**1<sup>st</sup> Further Information**

**Temporary Eating Place and Associated Filling of Land for a Period of 3 Years in  
"Commercial/Residential" and "Residential (Group D)" Zones, Lots 3250 S.B ss.24 S.A RP and  
3250 S.B ss.34 RP in D.D.104 and Adjoining Government Land, Mai Po, Yuen Long, New Territories**

**(S.16 Planning Application No. A/YL-MP/395)**

## Responses-to-Comments

| DWG. NO.:     | FS-1         |

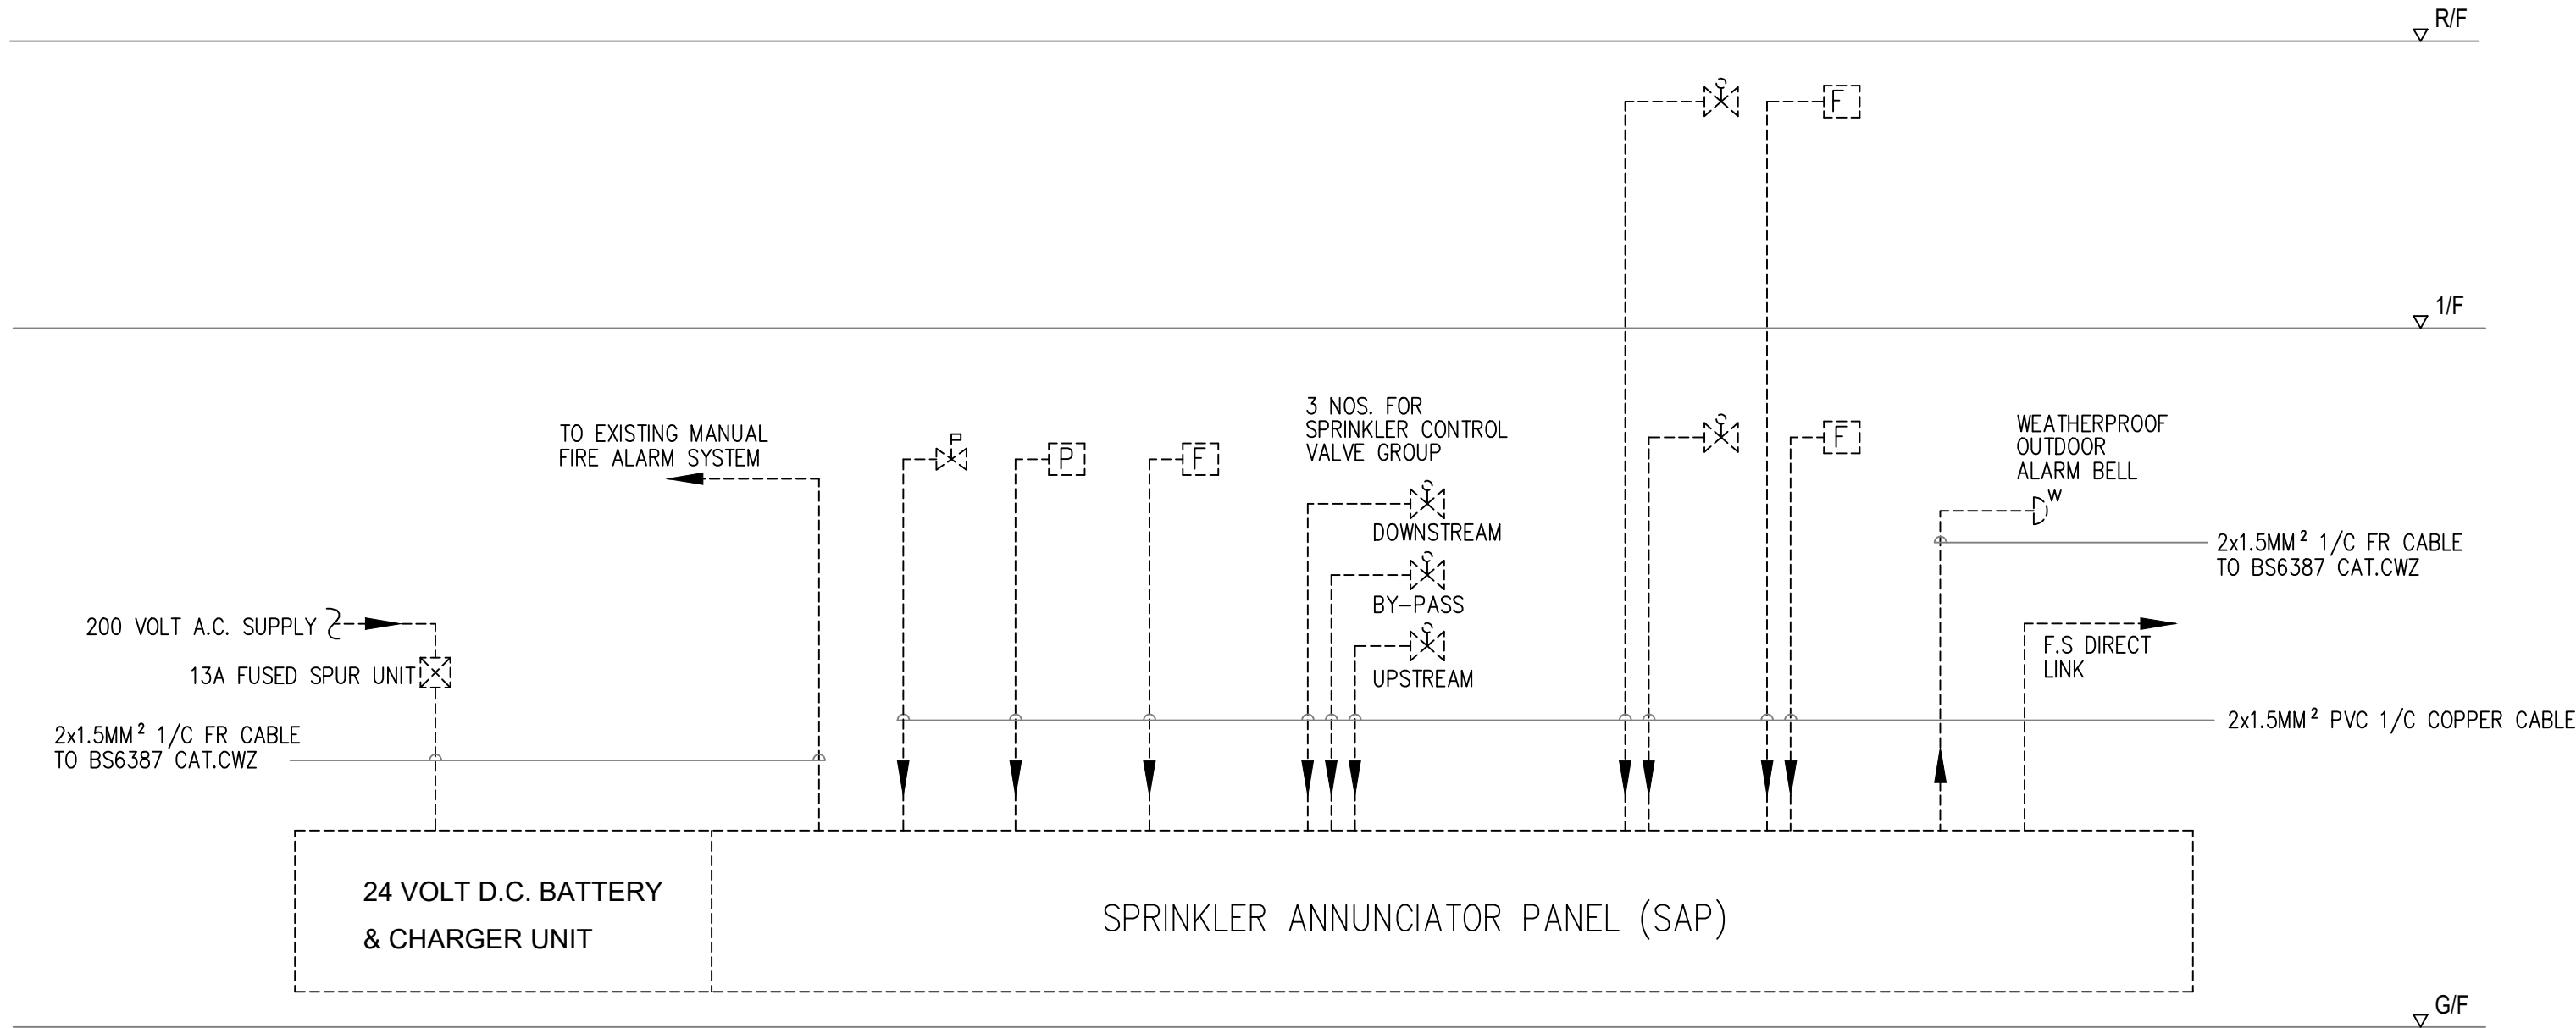
| <b>3. Comments of the Director of Fire Services (D of FS)</b><br><b>(Contact Person: Mr. CHEUNG Wing-hei; Tel: [REDACTED])</b> |                                                                                                                                                                                                                                                                                                                                               |                                                                                                                    |
|--------------------------------------------------------------------------------------------------------------------------------|-----------------------------------------------------------------------------------------------------------------------------------------------------------------------------------------------------------------------------------------------------------------------------------------------------------------------------------------------|--------------------------------------------------------------------------------------------------------------------|
| (a)                                                                                                                            | For enclosed structure with gross floor area exceeding 230m <sup>2</sup> , sprinkler system, wheeled type dry chemical fire extinguisher, Stand-alone Fire Detector, emergency lighting, directional and exit signs shall be provided;                                                                                                        | Noted and revised accordingly. Please refer to the revised fire service installations proposal ( <b>Annex I</b> ). |
| (e)                                                                                                                            | An automatic sprinkler system shall be provided in accordance with LPC BS EN 12845:2015 and the FSD Circular Letter No. 5/2020. The sprinkler tank, sprinkler pump room, sprinkler inlet and sprinkler control valve group shall be clearly marked on plans;                                                                                  |                                                                                                                    |
| (f)                                                                                                                            | Should the improvised sprinkler system is proposed, the applicant is required to submit two sets of FSI drawings and location plans with Form FSI/314A to his Department in accordance with the requirements stipulated in FSD Circular Letter No. 4/96 for further consideration.                                                            |                                                                                                                    |

- AN IMPROVISED SPRINKLER SYSTEM WITH WATER SUPPLIED FROM A DIRECT CONNECTION TO THE CITY TOWN MAINS AND IN ACCORDANCE WITH LOSS PREVENTION COUNCIL RULES FOR AUTOMATIC SPRINKLER INSTALLATIONS SHALL BE PROVIDED FOR THE PREMISES. THE HAZARD GROUP IS ORDINARY HAZARD GROUP 1 (OH1).
